A318/A319/A320/A321

TITLE : AIR CONDITIONING - INSTALL IMPROVED CLAMP ON BELLOWS AT PACK OUTLET AND
BETWEEN PACK OUTLET CHECK VALVE AND MIXER UNIT.

MODIFICATION No. : 35038K9698

SERVICE BULLETIN No. : A320-21-1155

Figure 1 Sheet 1
Replace the Clamps at Air-Conditioning Pack Outlets

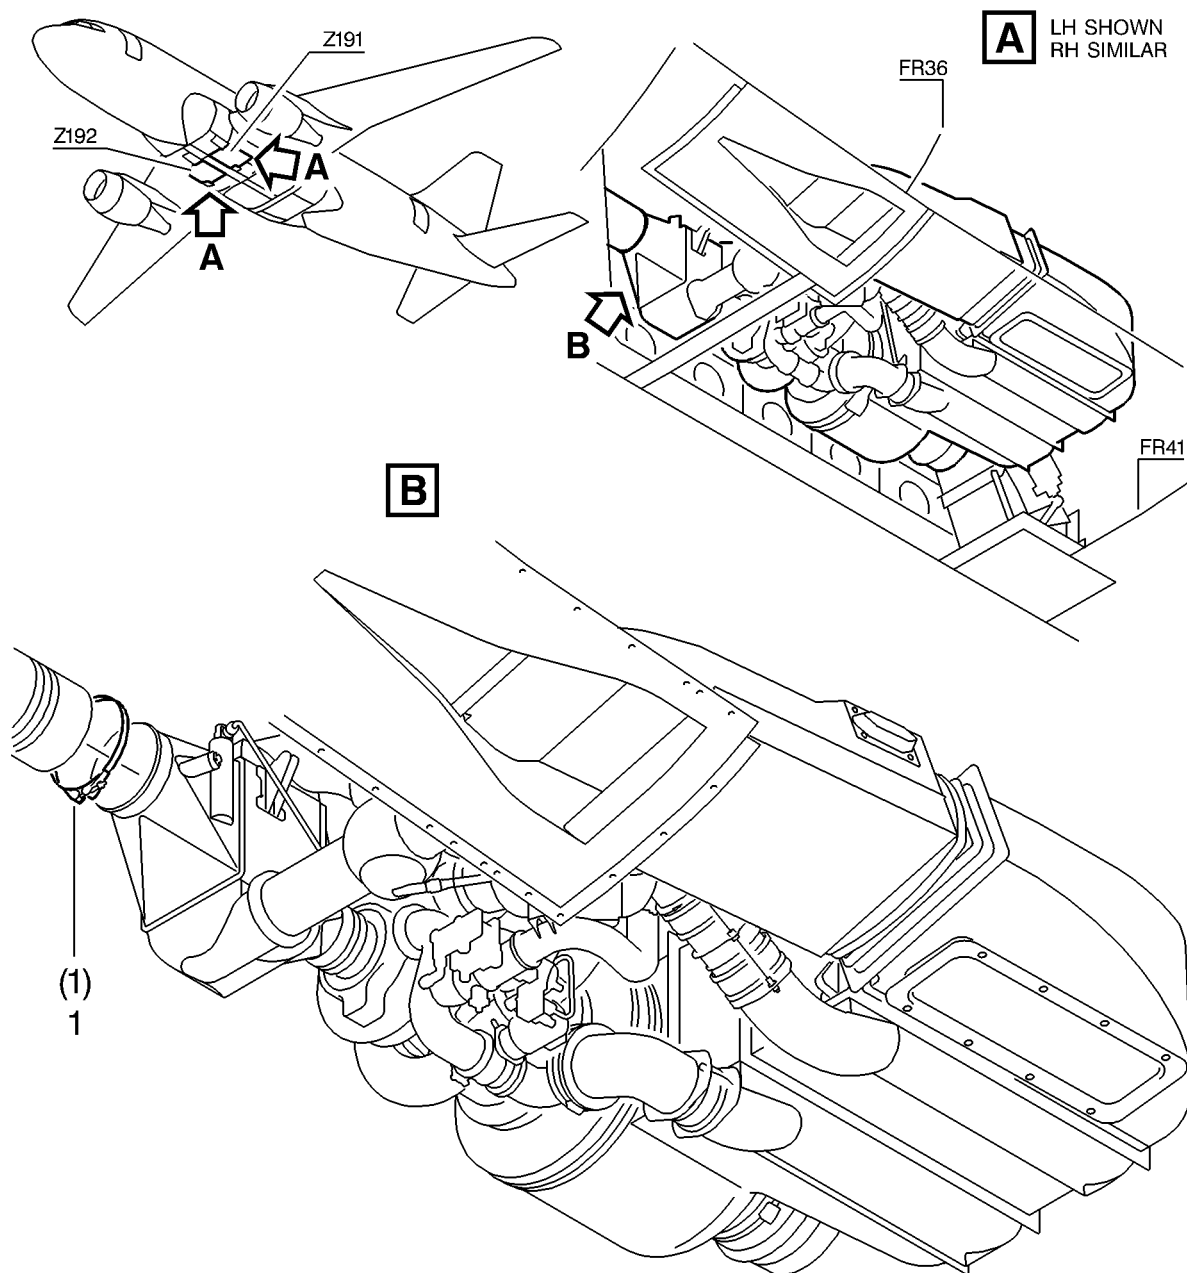
- (a) Replace the quick-disconnect clamp of the bellow at the air-conditioning condenser outlet duct of the LH pack 10HM at FR36.

Refer to Figure 1

- (b) Replace the quick-disconnect clamp of the bellow at the air-conditioning condenser outlet duct of the RH pack 11HM at FR36.

Refer to Figure 1

1 Remove as shown in Sheet 1 , Detail B :

1 clamp NSA5532-612 Item (1) Discard

3 Install as shown in Sheet 1 , Detail B :

1 clamp NSA5532C612 Item 1

4 Torque tighten the clamp to between 0.28m.daN (24.78lbf.in) and 0.38m.daN (33.63lbf.in).

1 Remove as shown in Sheet 1 , Detail B :

1 clamp NSA5532-612 Item (1) Discard

3 Install as shown in Sheet 1 , Detail B :

1 clamp NSA5532C612 Item 1

4 Torque tighten the clamp to between 0.28m.daN (24.78lbf.in) and 0.38m.daN (33.63lbf.in).

Figure 2 Sheet 1
Replace the Clamps at Mixer Unit

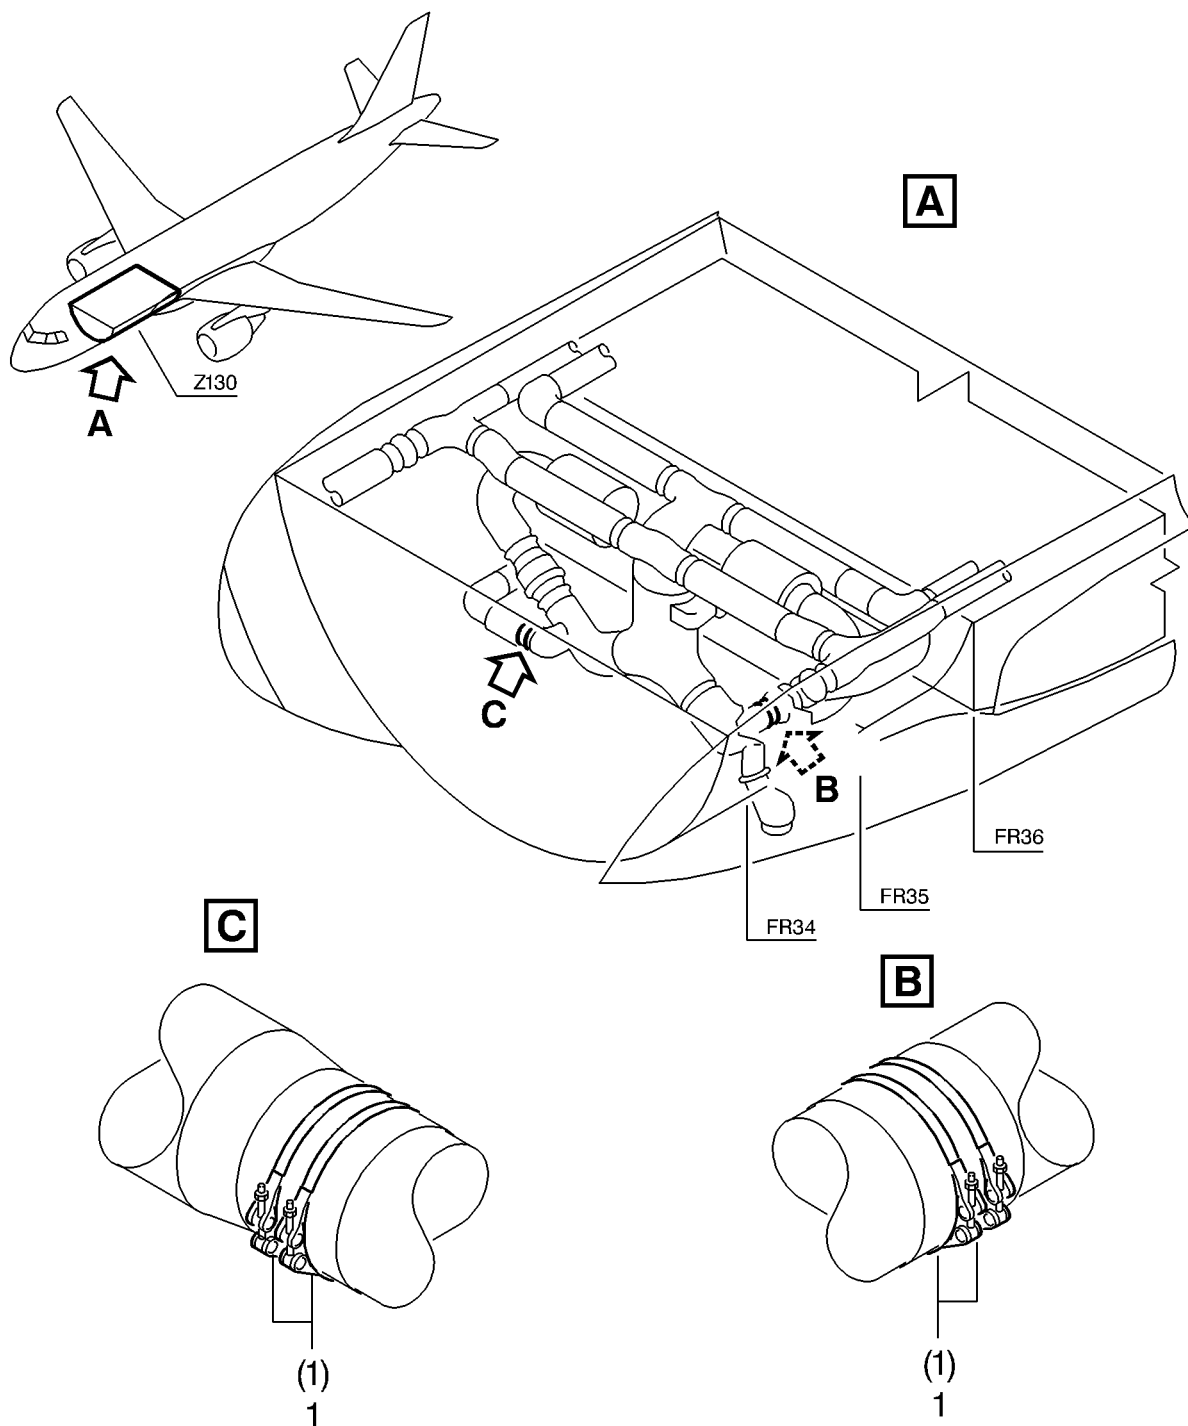
(c) Replace the quick-disconnect clamps for the bellow which connect the outlet check-valve of the air conditioning pack 10HM with the mixer unit between FR34LH and FR35LH.

Refer to Figure 2

(d) Replace the quick-disconnect clamps for the bellow which connect the outlet check-valve of the air conditioning pack 11HM with the mixer unit between FR34RH and FR35RH, STGR37.

Refer to Figure 2

1 Remove as shown in Sheet 1 , Detail B :

2 clamp NSA5532-612 Item (1) Discard

3 Install as shown in Sheet 1 , Detail B :

2 clamp NSA5532C612 Item 1

4 Torque tighten the clamps to between 0.28m.daN (24.78lbf.in) and 0.38m.daN (33.63lbf.in).

1 Remove as shown in Sheet 1 , Detail C :

2 clamp NSA5532-612 Item (1) Discard

3 Install as shown in Sheet 1 , Detail C :

2 clamp NSA5532C612 Item 1

4 Torque tighten the clamps to between 0.28m.daN (24.78lbf.in) and 0.38m.daN (33.63lbf.in).
